Access Compliance Report

Public Rights-of-Way

(Curb Ramps)

Intersection ID: 54461	Main Street: FENWAY_DR	Cross Street: FLINT_HILL_DR	Location: SE
ADA ID: 4E51C5DFF285	Ramp Type: Perp	Initial Pass/Fail: Pass	Overall Compliance: No
Codes/Mitigation Info/Possible Solution			Severity Score: 20
			Field Measurements/Component Compliance

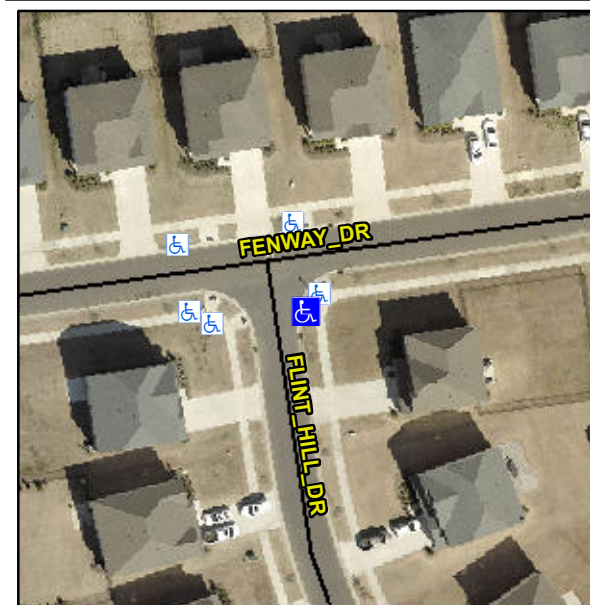
R305.2, R302.7.2, R304.5.4

Remove & Replace Detectable Warning System. Remove & Replace Gutter.
